# County of Santa Clara

### STAFF REPORT Zoning Administration February 2, 2023 **Item #1**

## **File: PLN21-021**

### **Concurrent Land Use Permit of a Building Site Approval on Slope 30% or Greater, Grading Approval, and Design Review for a New Single-Family Residence.**

### **Alternate Site Map**

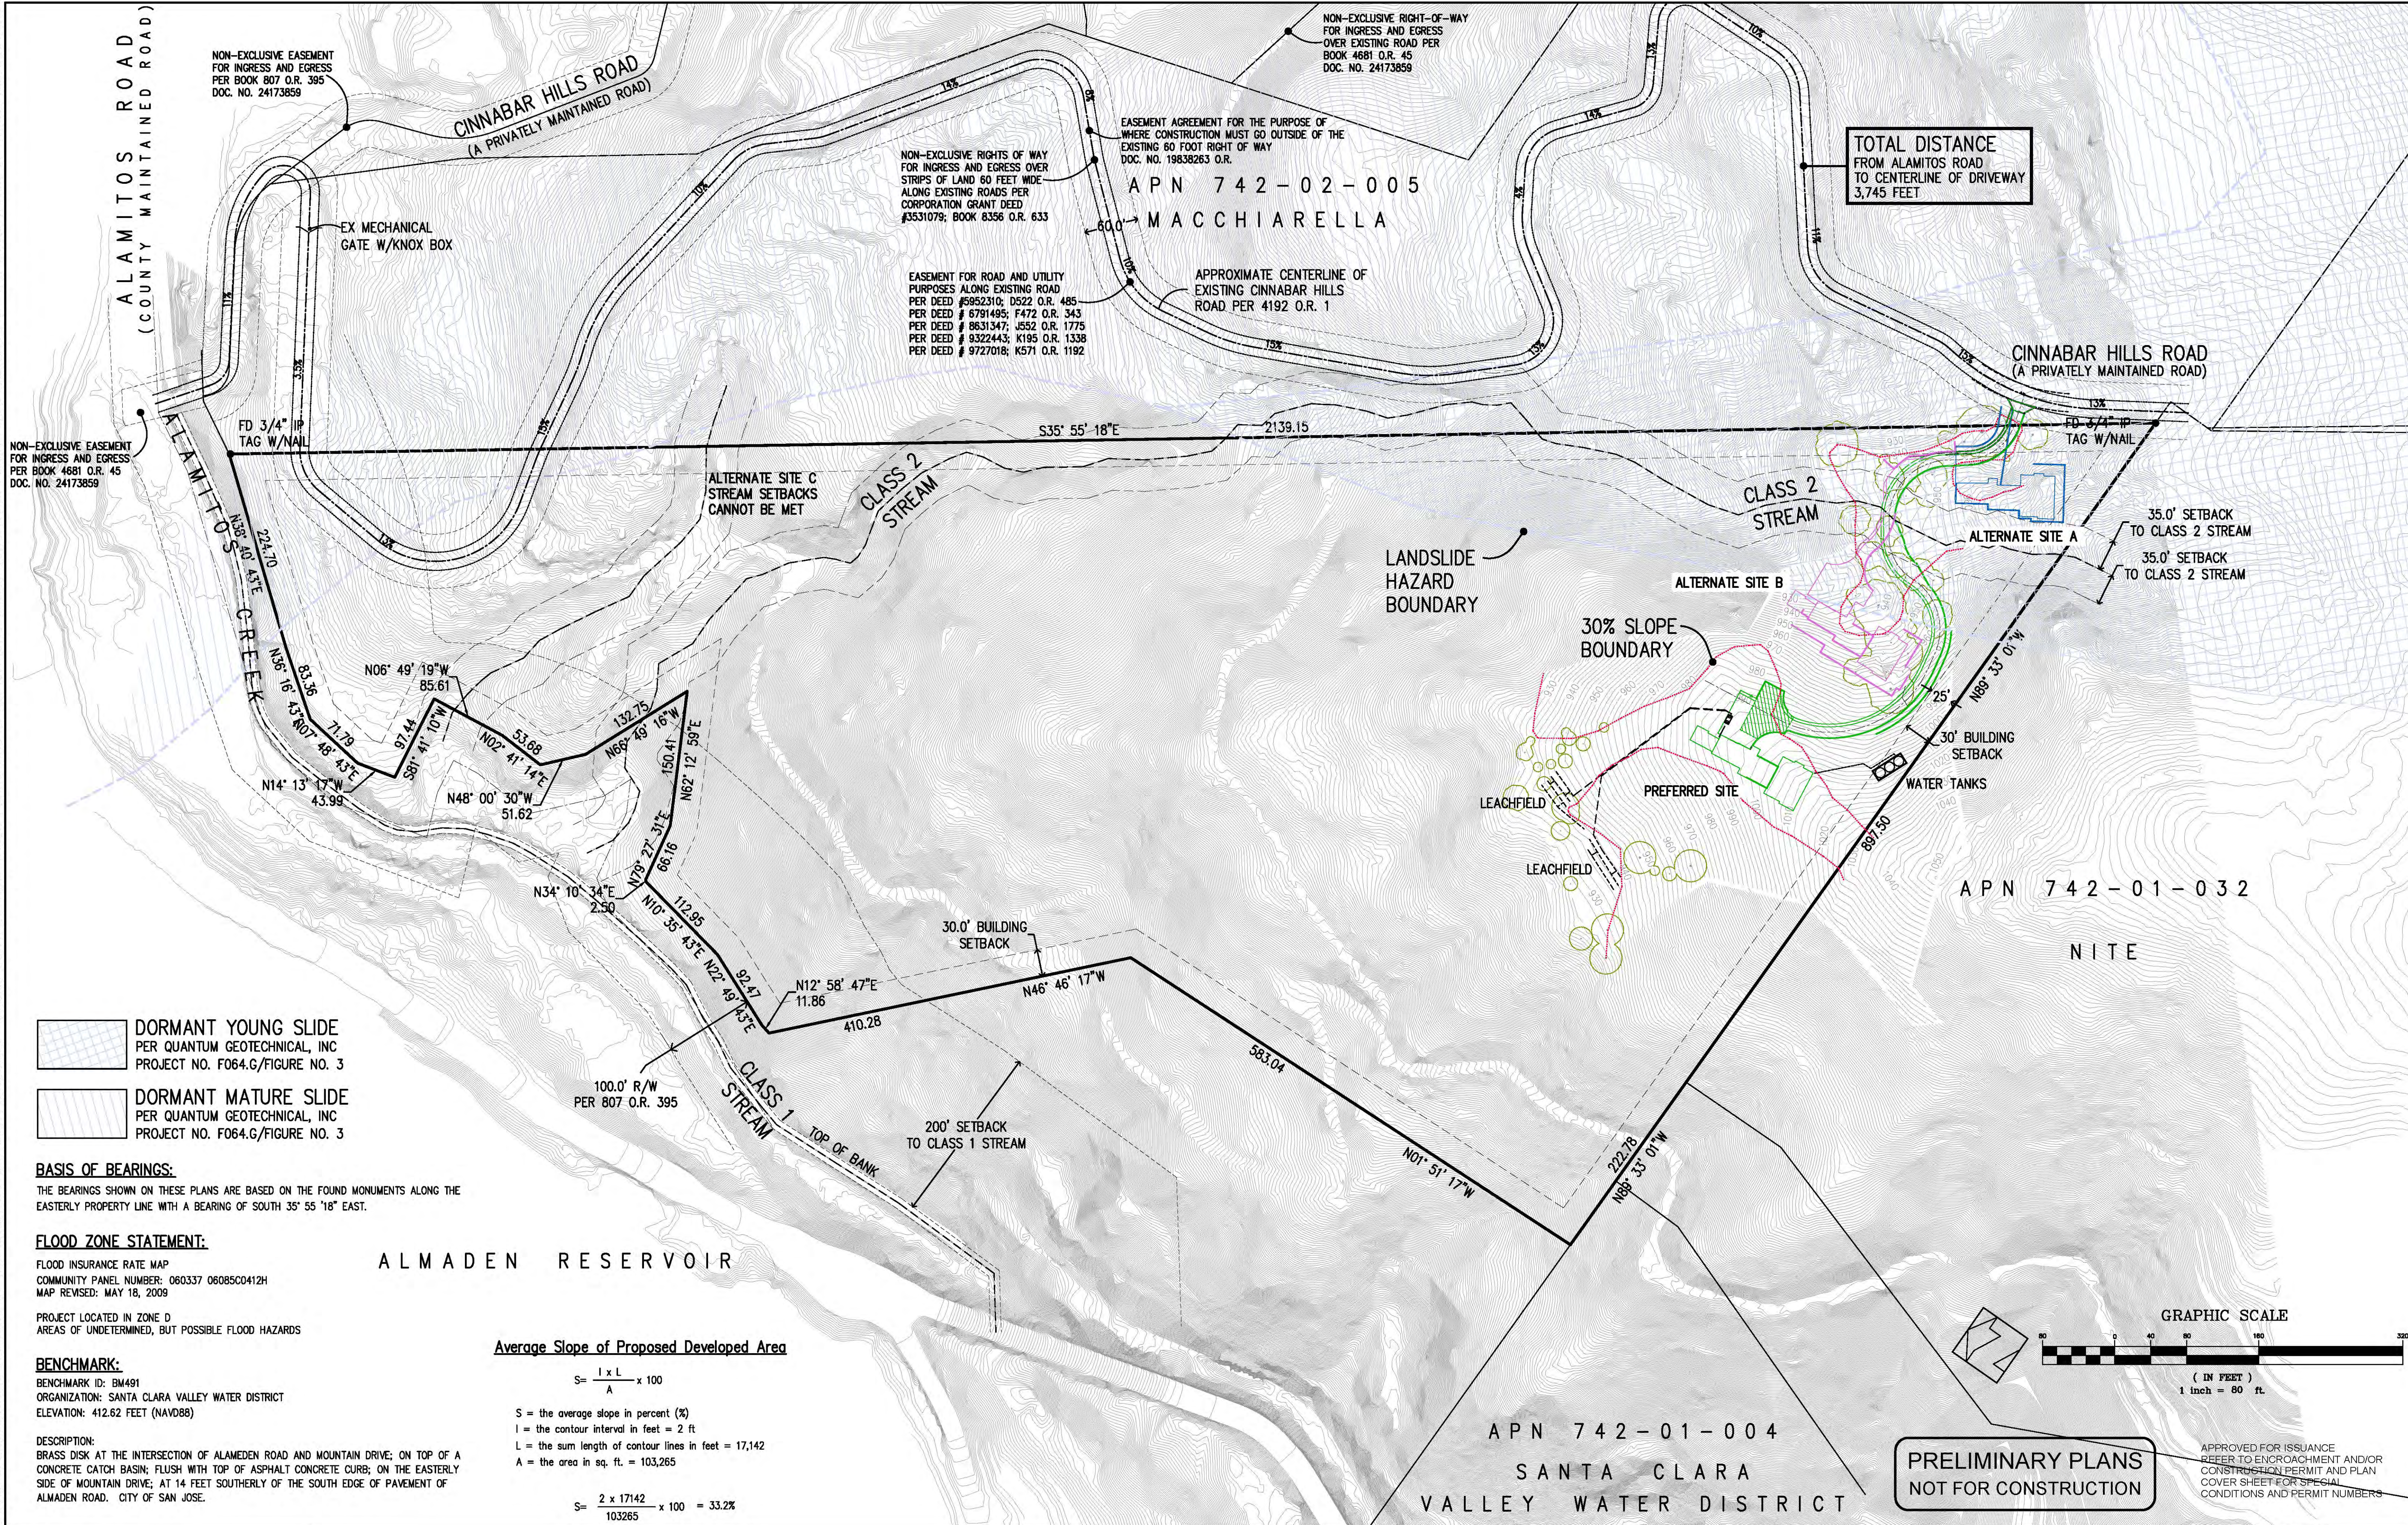
Considering the previous hearing comments and discussion, staff seeks to provide additional details regarding the Alternative Site Analysis for the project to provide clarity for the record. There were three alternative sites considered for this project. The Alternative Site Plan Map can be viewed in Attachment E of this report. In brief, Alternate Site A is entirely within the mapped landslide hazard area. In addition, the surrounding terrain is very steep and densely wooded and limited by the riparian setback from the creek. Alternate Site B is the flattest spot on the west side of the creek, however, due to the surrounding slope the house would require retaining walls up to 17 ft high. In addition, the topography of this area is a natural draw for storm drainage. While it this water channel not an official stream or creek, a significant amount of water collects and flows through this area during rain events. Alternate Site C is a flat area is located near a second existing dirt road allowing for development to be located away from the creeks and the landslide hazard areas.

7. Expand on finding C of the Building Site Approval findings.
  - a. Section C(c) has been modified to better explain the constraints for building on any areas of the site with less than 30% slope. Because the overall slope of the parcel exceeds 40%, there are very few flat sections to consider as potential development sites. Additional analysis of the potential site C was added to Section E(1) to support the findings for Grading Approval.

### **Roofline Modification**

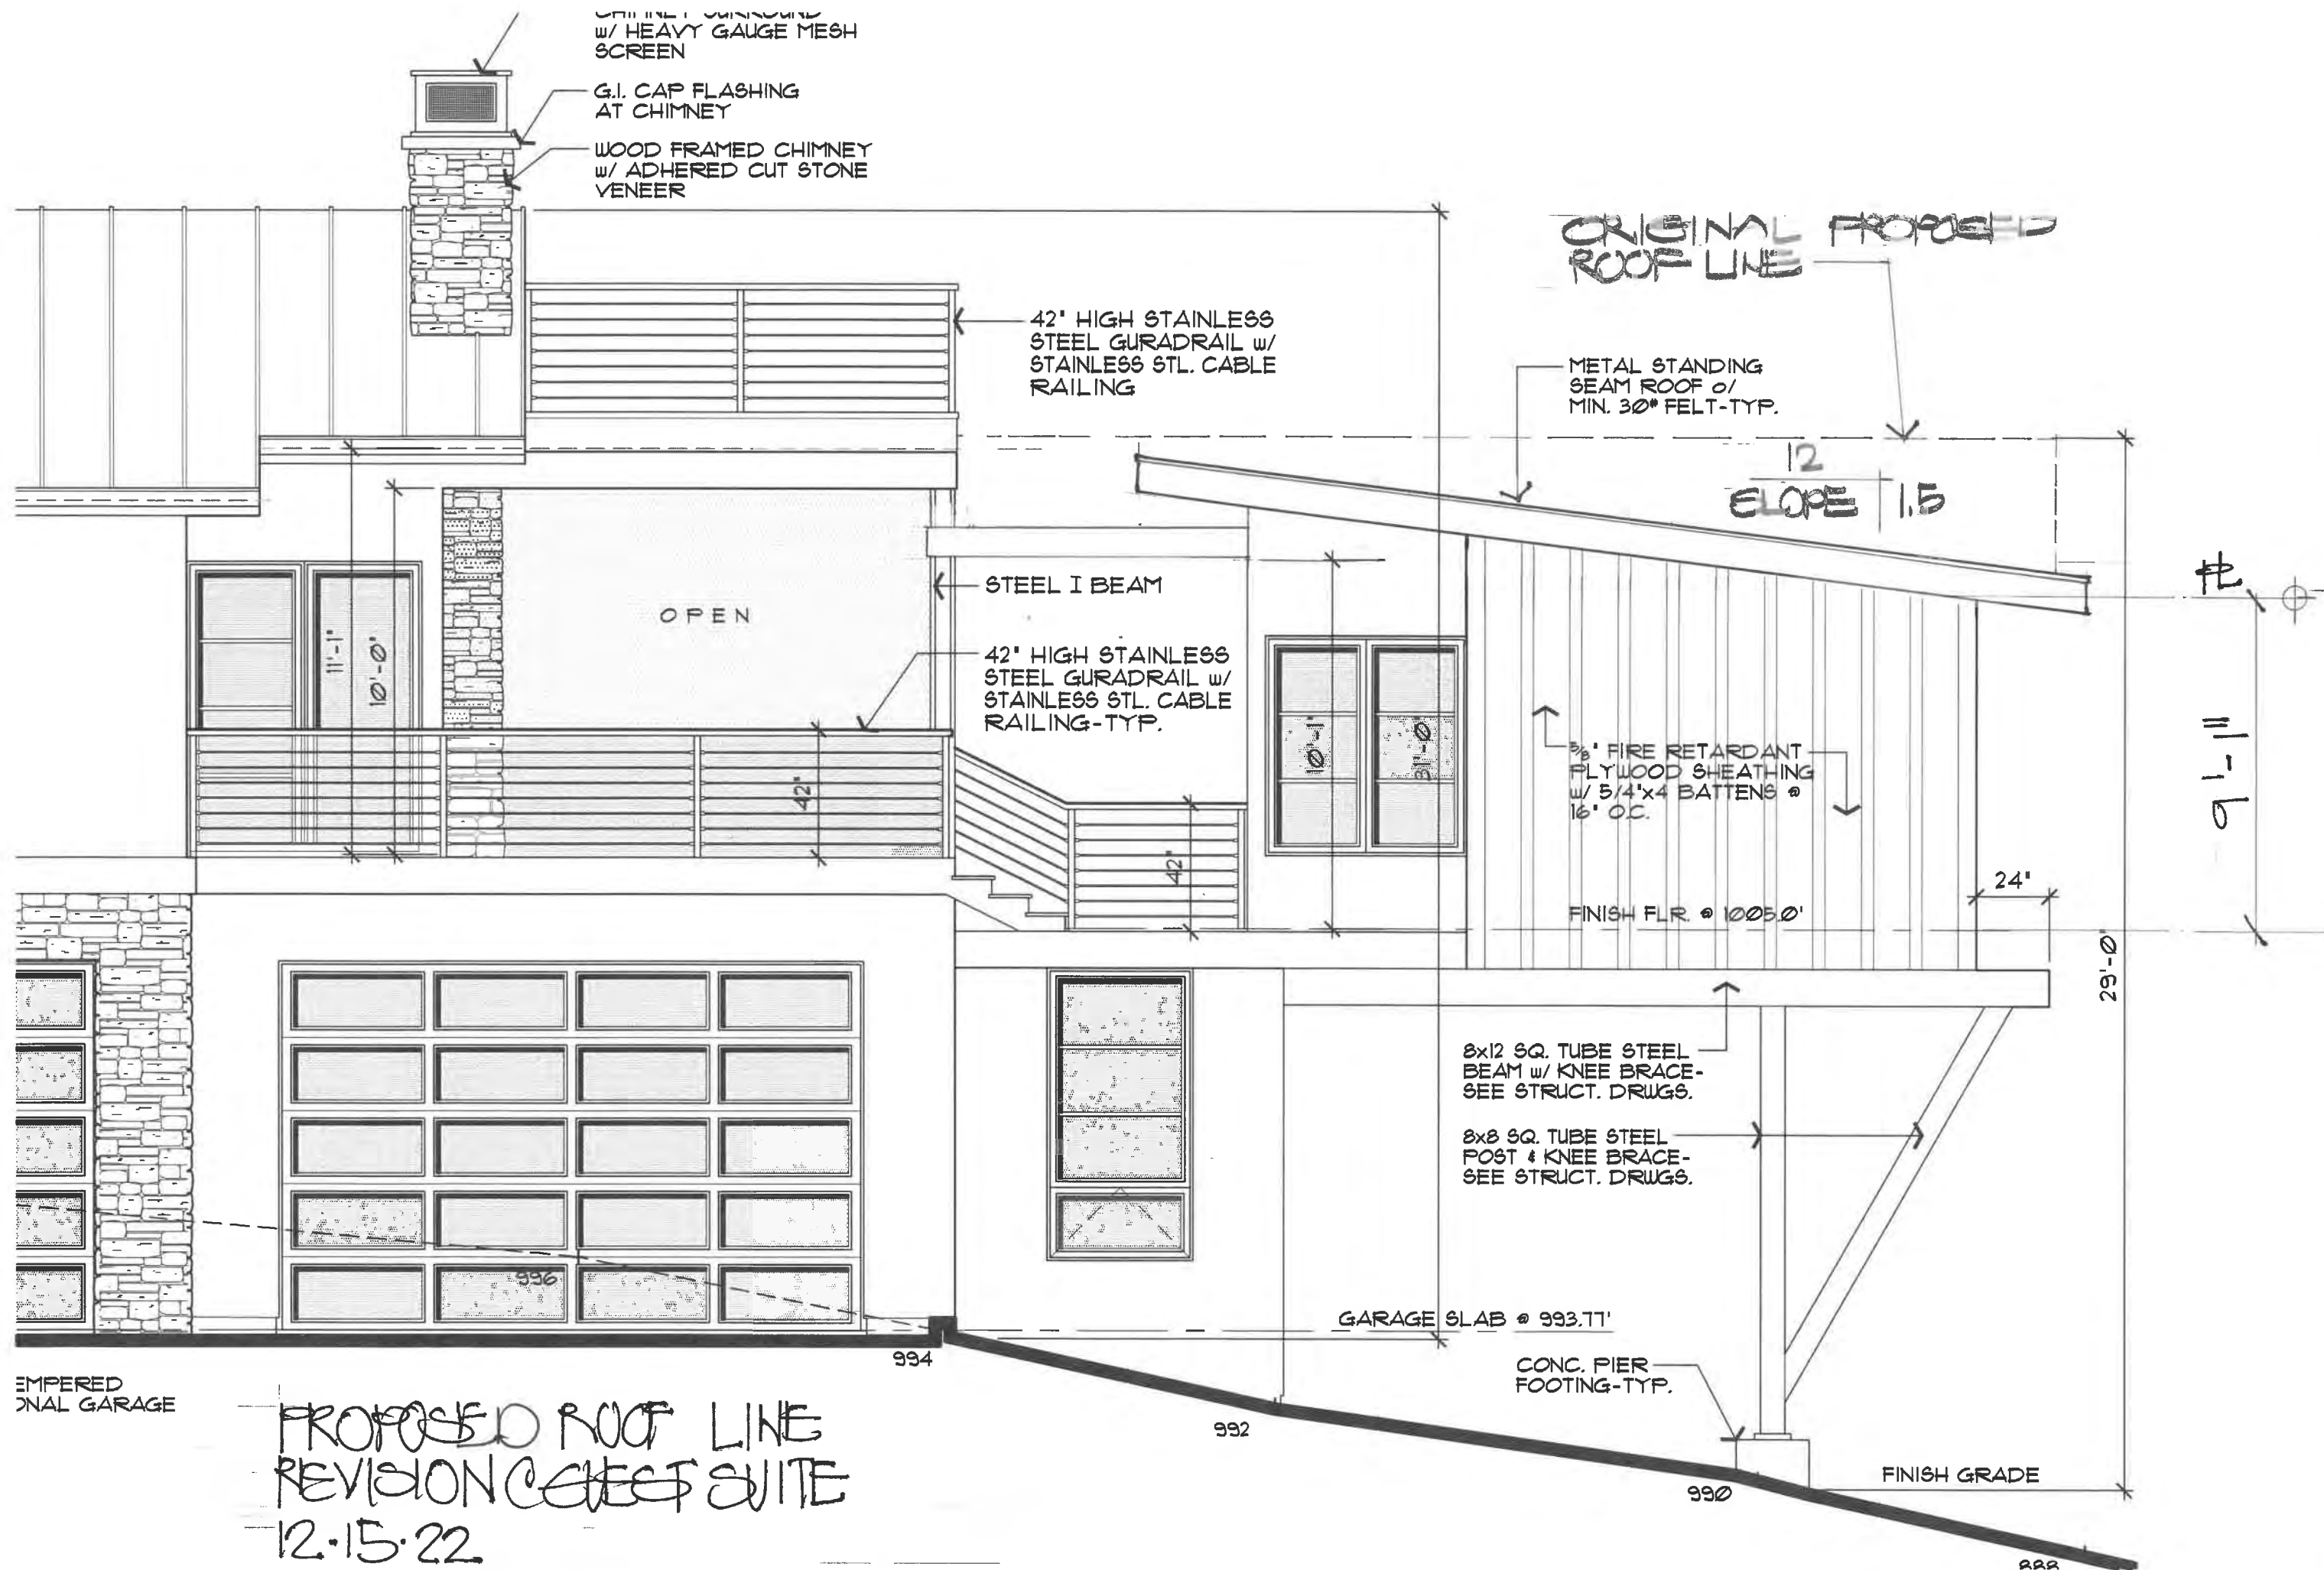
4. Is the modified roofline a condition of approval? Did applicants already make the amendment and is that what we are reviewing?
  - a. The modified roofline is a Condition of Approval (#1) and was reviewed and recommended for approval by the Historic Heritage Commission on December 15, 2022. The changes have not been made to the submitted plans, Condition of Approval (#1) requires the modified roof plan to be included in the plan set submission for building permits. Many of the intended attachments for the January 12, 2023, Zoning Administrator Staff Report Item #1 were inadvertently left out of the posted public record. The correct attachment for modified roofline (Attachment F) has been added to this report.

rooflines conform to these guidelines; however, the sloped roofline of the guest suite/office (on the north side of the structure) clearly stands out both as a distinct projection from the hillside and for its modern, industrial looking design. Staff finds the roofline does not conform with the design standards and recommends a modification to this roofline to better conform to the natural slope and reduce visibility to the valley floor and adjacent hillsides (see Attachment F). The project is consistent with the recommended standards found in § 3.50.090(E)(2) and § 3.50.090(E)(4).

Staff finds that the materials and architectural features of the proposed residence with the inclusion of the modified guest suite roofline as proposed in Attachment F generally conform with the design standards of § 3.50.090(E)(1)-(9).
